U.S. Department of Energy
Office of Civilian Radioactive Waste Management

Repository Design and Thermal-Mechanical Effects

Presented to:
DOE/NRC Technical Exchange on the Key Technical Issue and Subissues Related to Repository Design and Thermal-Mechanical Effects

February 6-8, 2001
Las Vegas, NV

Justify Mechanical Properties for Continuum Rock Mass Modeling

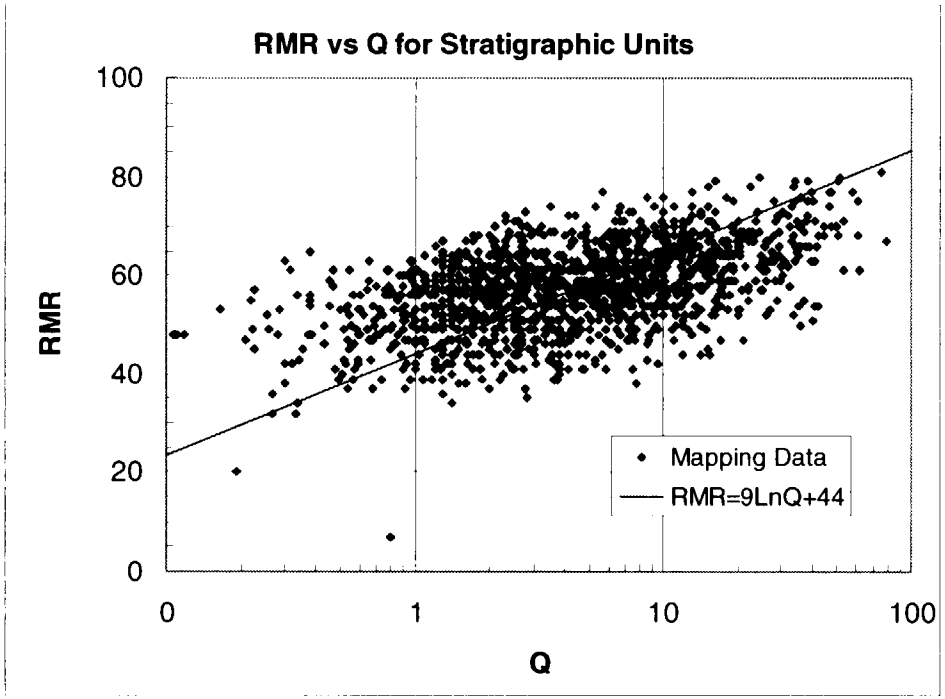
- **Design analyses use appropriate models and site-specific properties of the host rock and consider spatial and temporal variation and uncertainties in such properties**
- **Action or Information Needs**
  - Justify mechanical properties for continuum rock mass modeling
  - Justify mechanical properties for discontinuum rock mass modeling
  - Provide basis for mechanical degradation of rock support materials
  - Justify thermal-mechanical modeling
- **Basis for Closure**
  - Ground support analyses have considered the site conditions, postulated loadings, and available modeling approaches
  - Ground support analyses have considered combinations of continuum and discontinuum modeling methods

- **Basis for Resolution**
  - Values of the rock mass rating (RMR) and rock mass quality (Q) for both lithophysal and non-lithophysal rock masses show the empirical correlation by Z. T. Bieniawski is applicable

Modeling of Joint Plane Radius
(Continued)

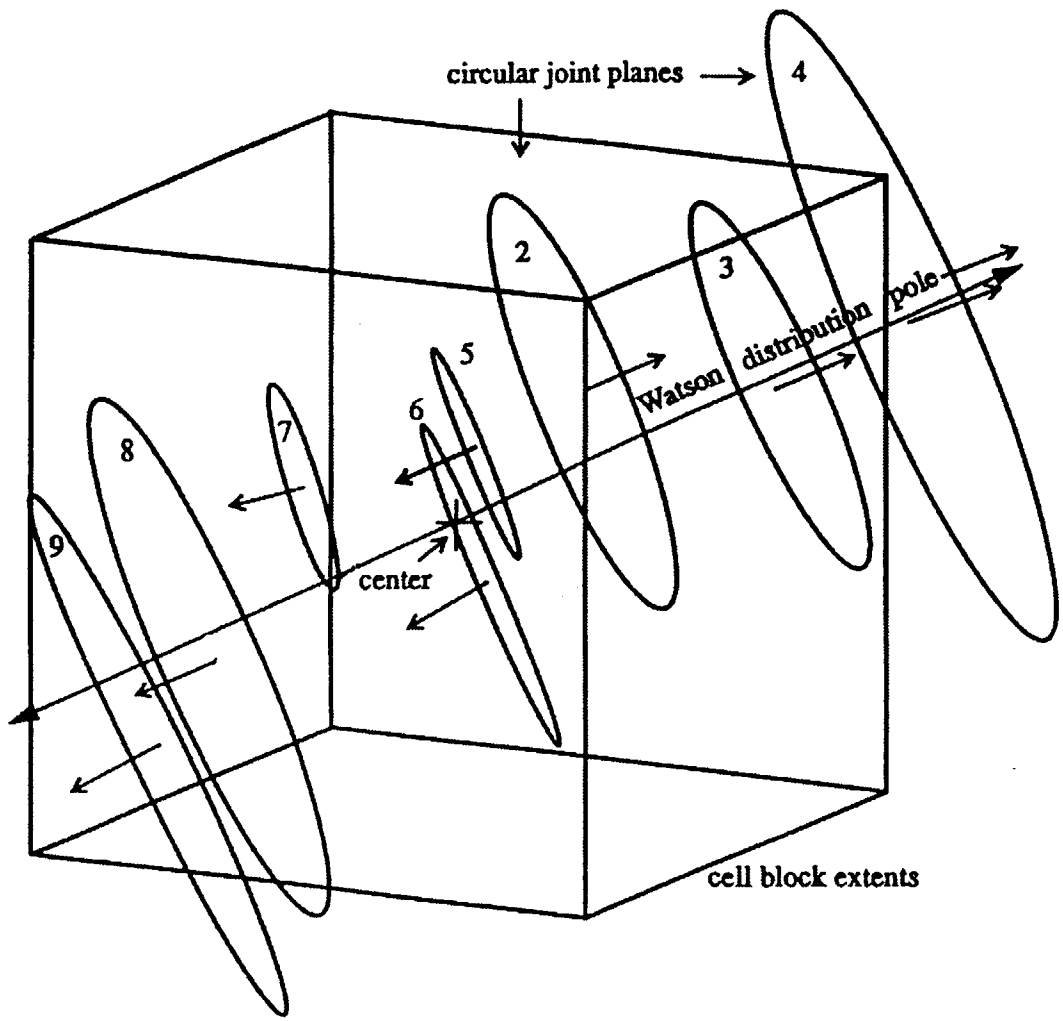
- **Action or Information Needs**
  - Basis of assumption regarding modeling of joint plane radius
  - Representativeness of joint mapping data
  - Basis for exclusion of small joint trace lengths
  - Treatment of thermal and long-term degradation of joint strength
  - Joint sampling bias
  - Temperature dependency of titanium material properties
  - Design basis rock size
  - Use of 10^{-4} ground motion values for postclosure seismic ground motion analysis
  - Verification of key block analysis approach

- **Basis for Resolution**
  - The size and frequency of blocks observed in the Exploratory Studies Facility agrees with the static results from the key block model, thus validating the assumption that the radius of the joint plane in the rockfall model is equal to twice the mapped joint trace length
  - The use of shorter trace lengths would lead to less fracture connectivity and therefore fewer blocks would form
  - The use of shorter trace lengths does not cause the formation of larger blocks since it must be kinematically feasible to move into the opening

- Individual joints within each joint set are represented as circular discs in three-dimensional space. Mean disc radii are typically 4 m or less
- A 26.8 x 26.8 x 26.8 m rock mass volume was modeled represented by a mesh of 680,000 grid points. A 5.5-m diameter, 24.4-m length tunnel was modeled through the center of the rock mass
- The modeled rock mass was sufficiently large to include the full extent of rock failure. Potential "end effects" on block development are diminished with multiple Monte Carlo simulations
